INNER WEST

DEVELOPMENT ASSESSMENT REPORT

Application No.	DA/2020/0971
Address	14 Llewellyn Street BALMAIN NSW 2041
Proposal	Alterations and additions to existing dwelling-house
Date of Lodgement	19 November 2020
Applicant	Ms Sophia Read-Hamilton
Owner	Ms Sophia Read-Hamilton Mr Paul J Box
Number of Submissions	Nil
Value of works	\$380,000.00
Reason for determination at Planning Panel	Clause 4.6 variation exceeds 10%
Main Issues	FSR variation of 15.97% Impacts on Heritage Conservation Area
Recommendation	Approval with Conditions
Attachment A	Recommended conditions of consent
Attachment B	Plans of proposed development
Attachment C	Clause 4.6 Exception to Development Standards
Attachment D	Statement of Heritage Significance

Drawing No.: **DA04**
 The holder shall obtain and verify all dimensions from the Architect. Do not show the drawing. Drawings are the property of the Architect and shall not be used for any other purpose without the written consent of the Architect.
 Issue A
 Date: 26/10/20

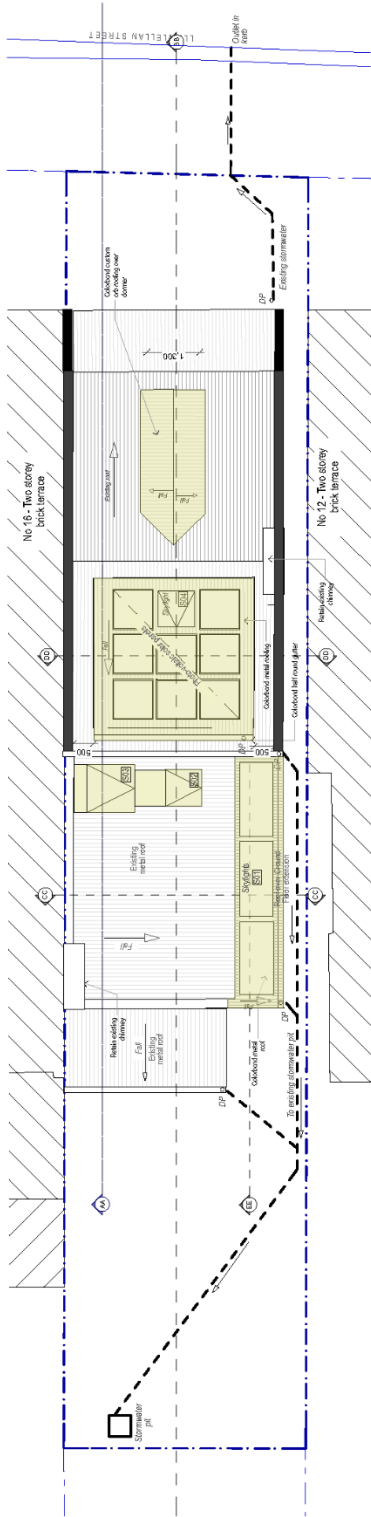
- a. The stormwater drainage concept plan on Drawing No. DA04 issue (A) prepared by archology architecture and dated 26 October 2020, must be amended to comply with the following;
- b. Stormwater runoff from all roof areas within the property being collected in a system of gutters, pits and pipeline and be discharged, together with overflow pipelines from any
